Treatment and Disposal of Waterworks Sludge from Existing Water Treatment Works

Environmental Impact Assessment Final Assessment Report

October 1995

Final Assessment Report

Figure 1.1 Location of Proposed Development Sites and Sludge Disposal Points

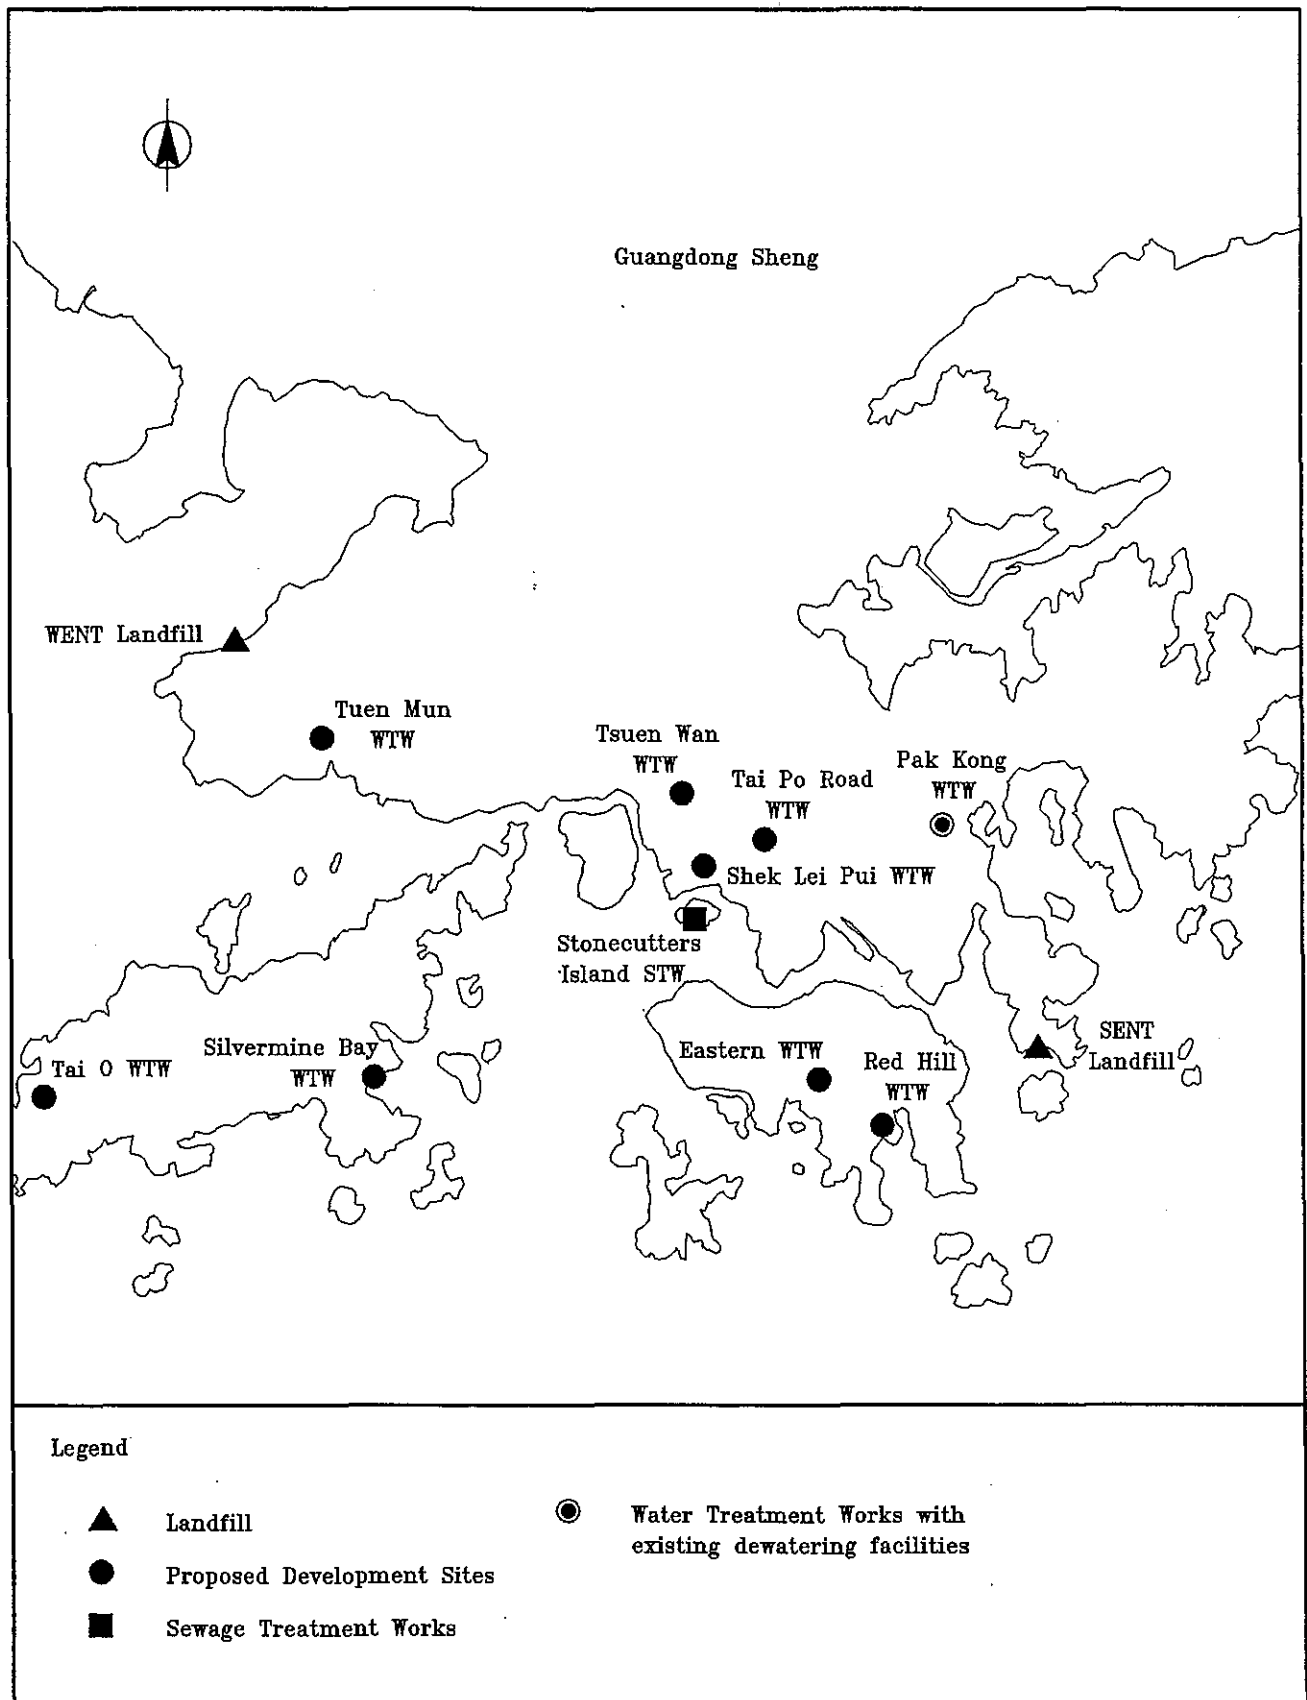
- Agreed - the relevant text shall be amended.
- ii) Figure 1.1
 We support the addition of Figure 1.1 to illustrate the locations of the sites. However, different notations shall be used for proposed development sites and the solution site at Pak Kong. The inclusion of Aberdeen on the plan needs to be documented in the text, otherwise, we don't see the point of marking Aberdeen on the figure. (For WSD's internal consideration: We prefer to take it out).

- Agreed - Notations on Figure 1.1 shall be amended and notation for Aberdeen shall be removed from the Figure.
- iii) Page ii
 For those "Proposed Developments" (especially for Tai O), somehow the text should state the items listed are original proposals that will subject to detail checking during the EIA/BEECOPS test (otherwise members might have difficulties in understanding the recommendation for further studies in Tai O).

Figure 5.1
Proposed Development and Nearest Sensitive Receiver Location-Eastern WTW

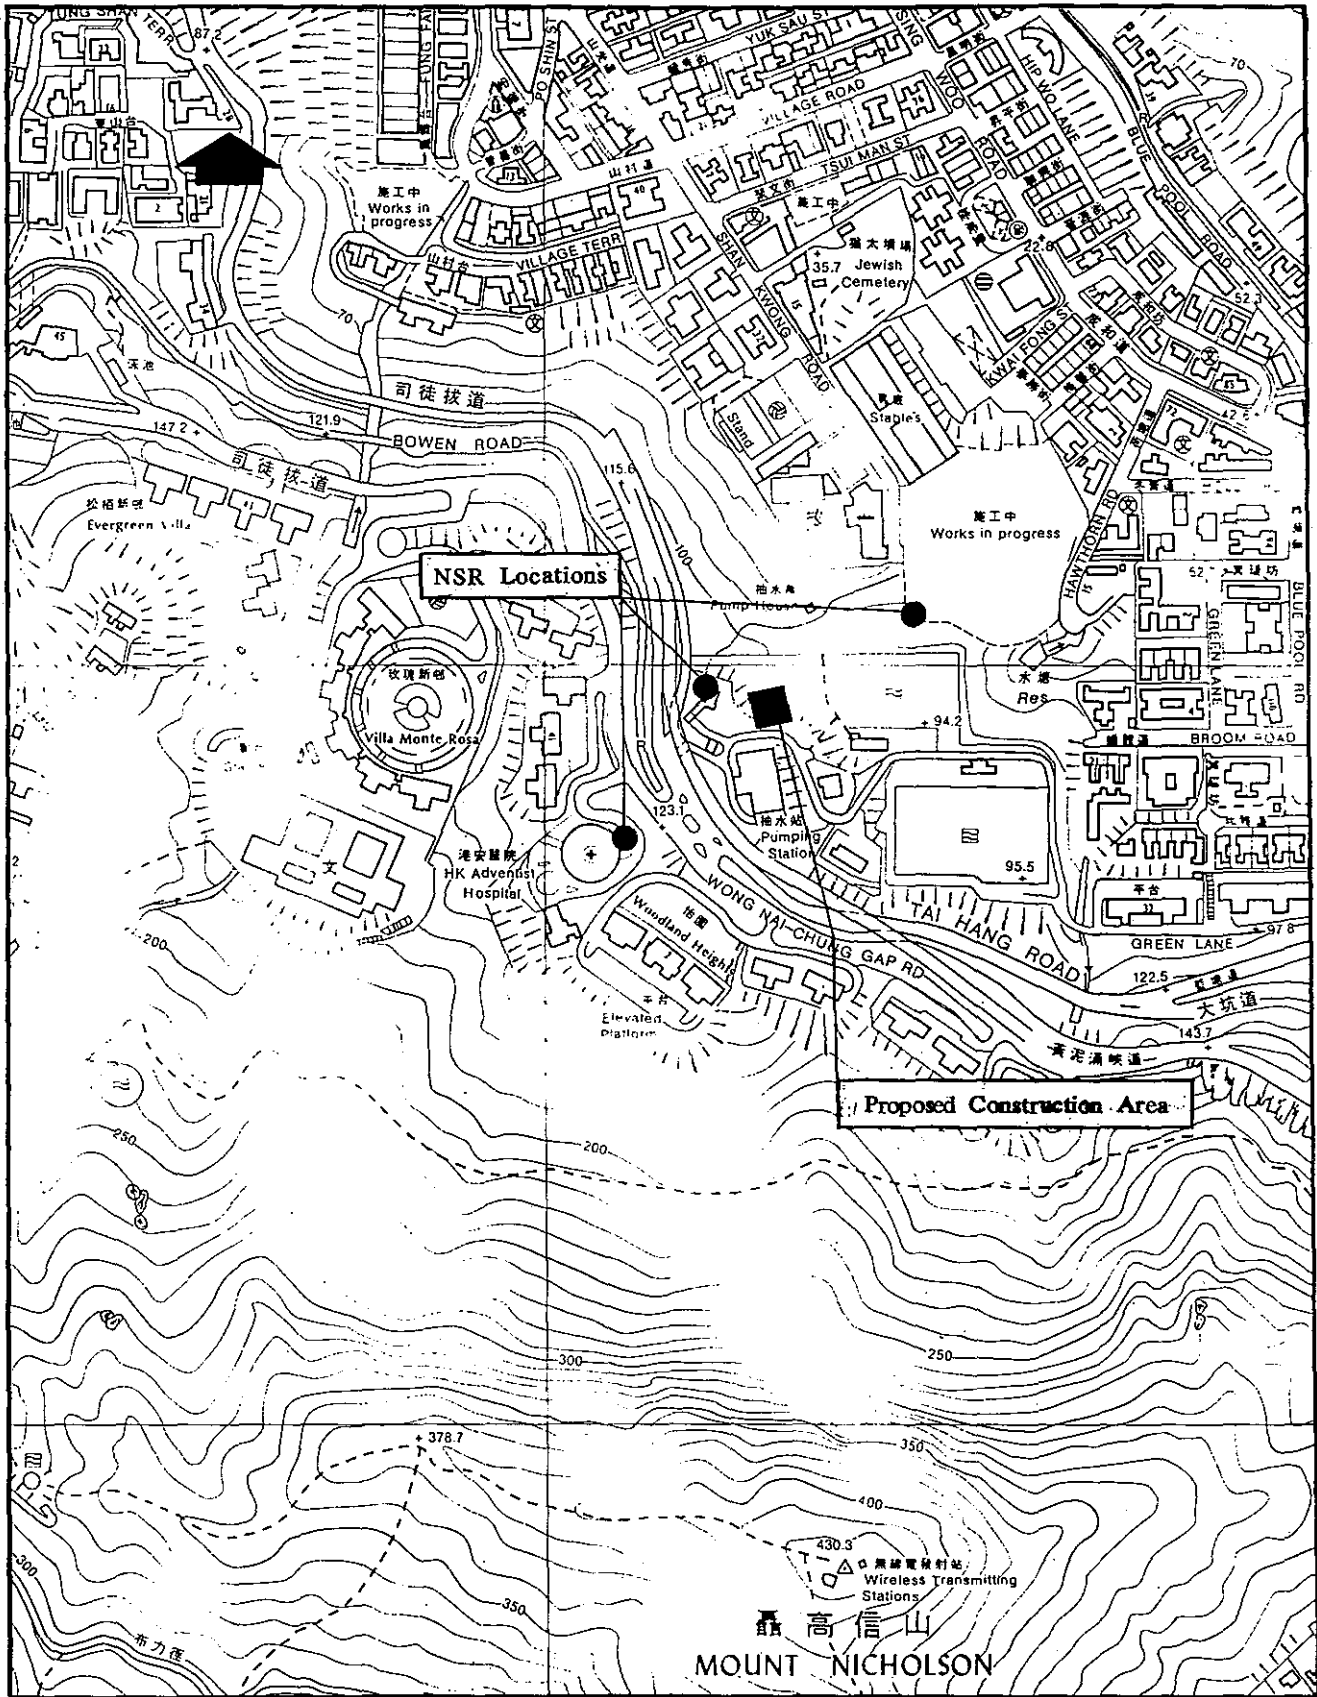
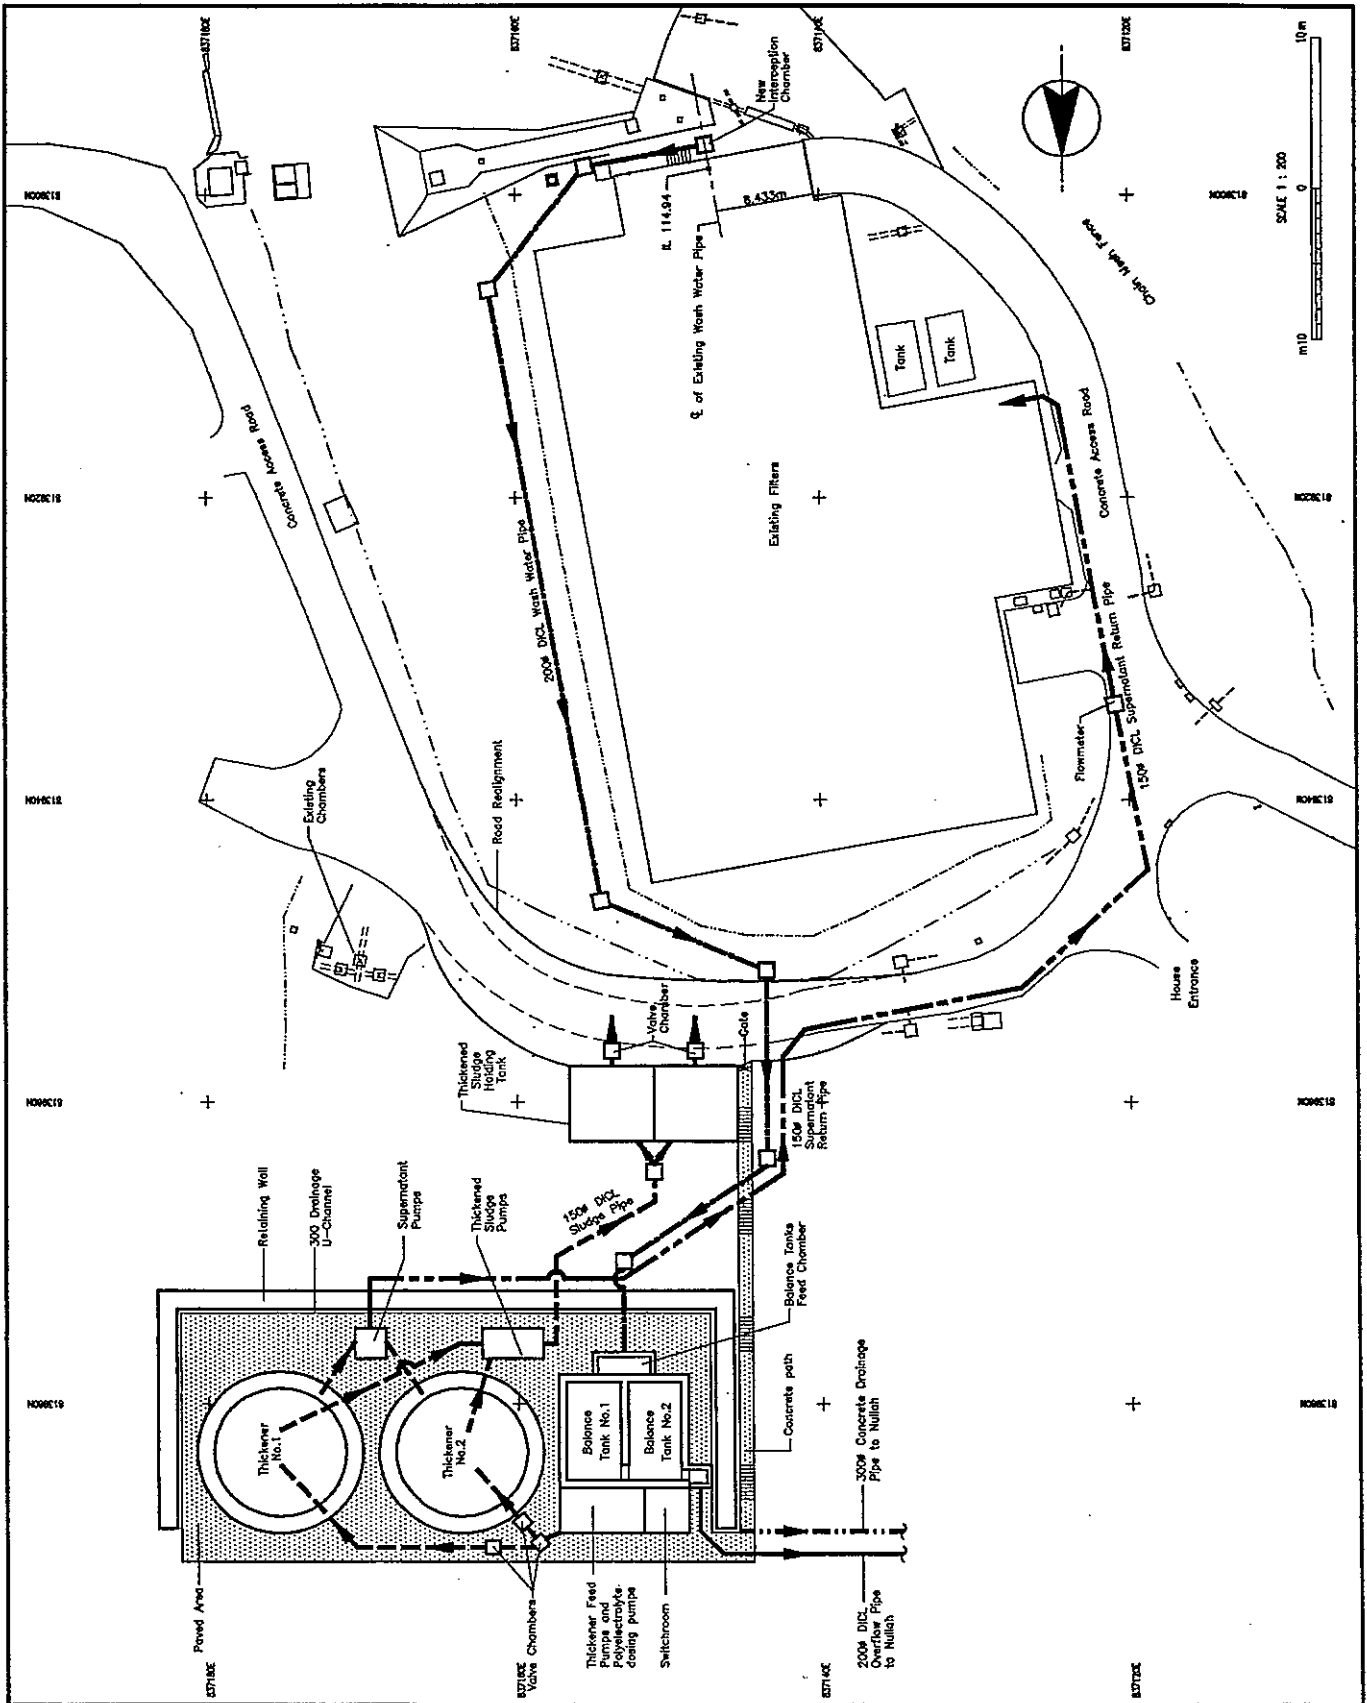
| a) Location of construction site as shown in Figure 5.1 and 5.2 are different. Please request the consultant to clarify. | The drawings will be aligned. |

Figure 6.2 : Layout of Proposed Sludge Treatment Facilities at Red Hill WTW

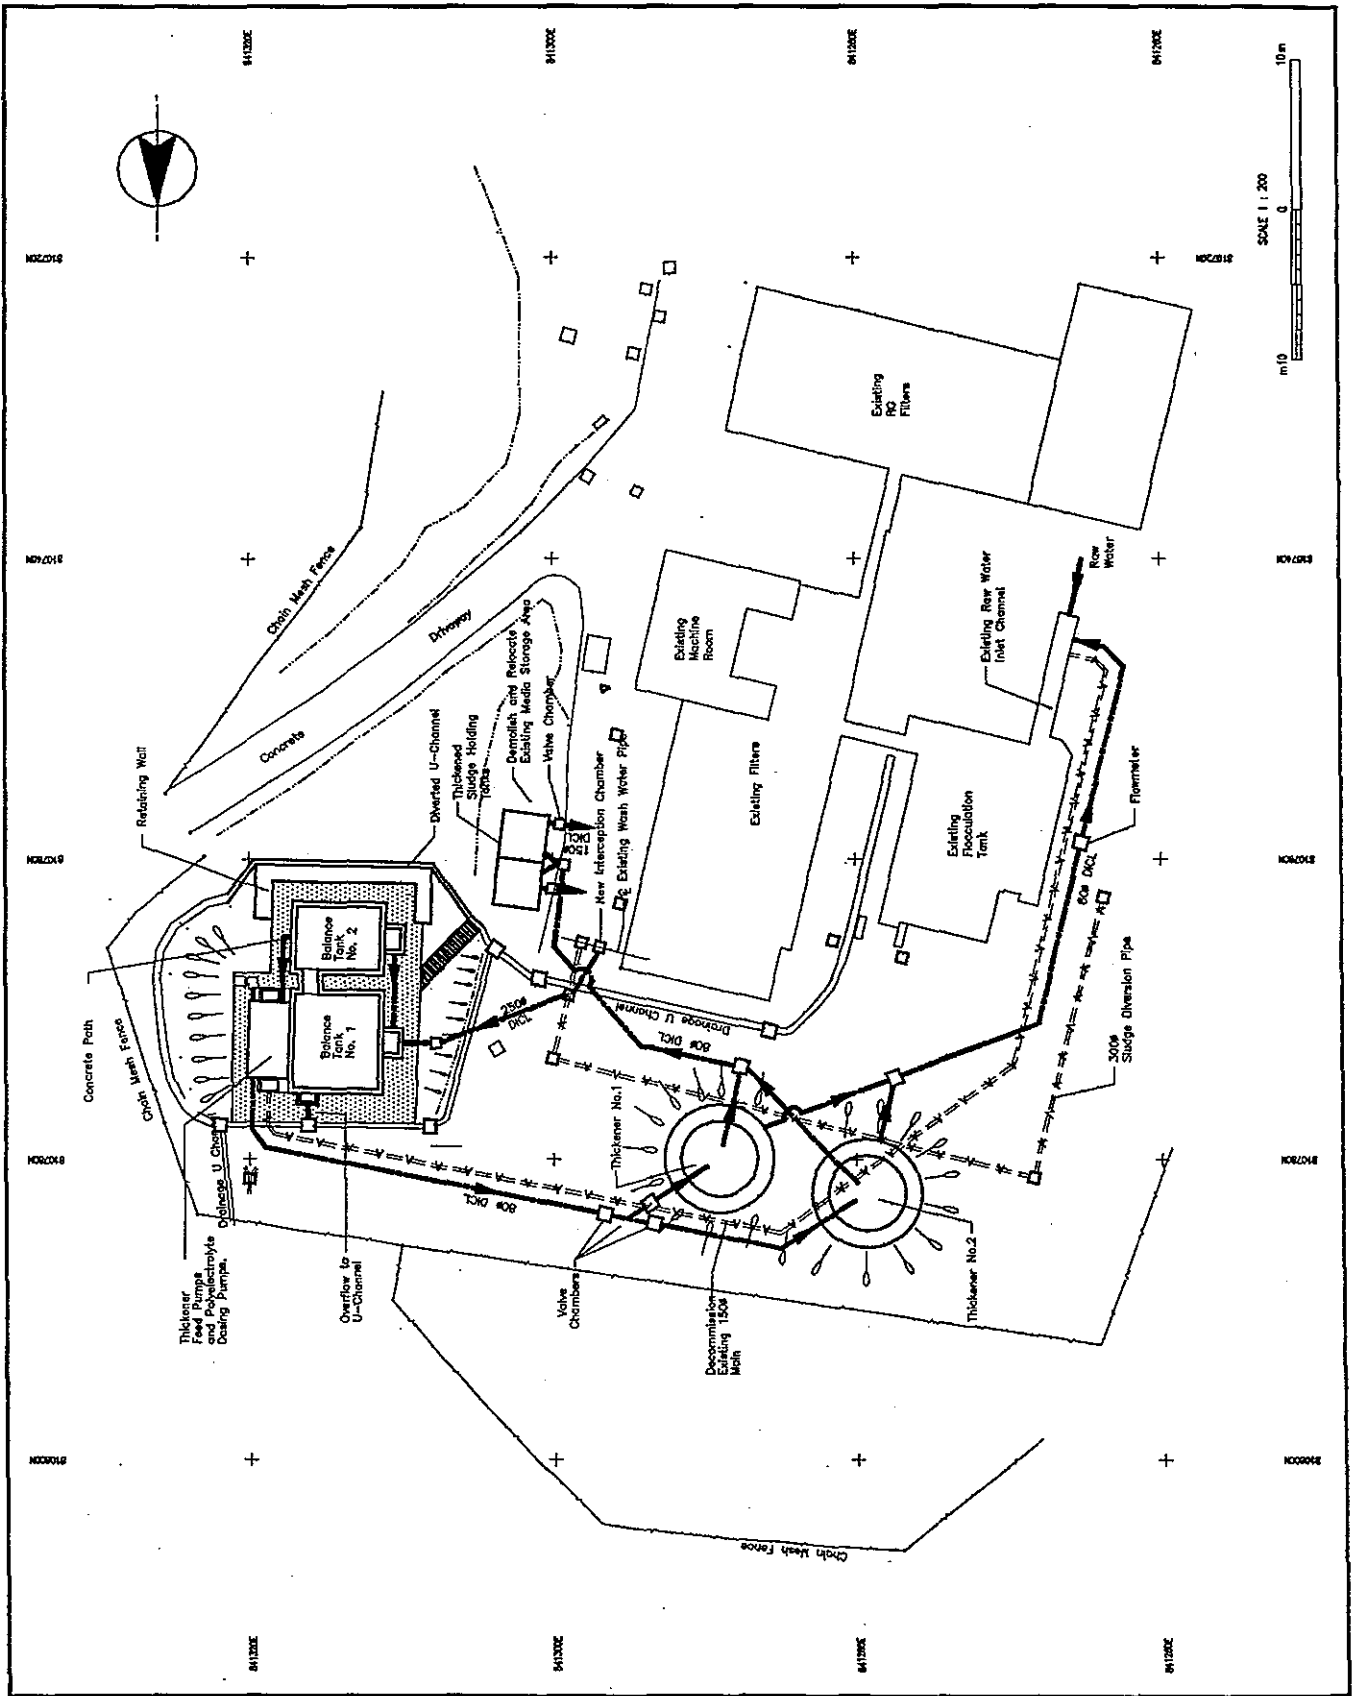
| c) Figure 6.2, opposite page 42, should clearly show how the sludge from the flocculation tank would be conveyed to the sludge balancing tank after the existing 300 mm diameter pipe is decommissioned to give space for construction of the proposed facilities. | The term "decommission" will be removed as the pipe is not to be decommissioned. |
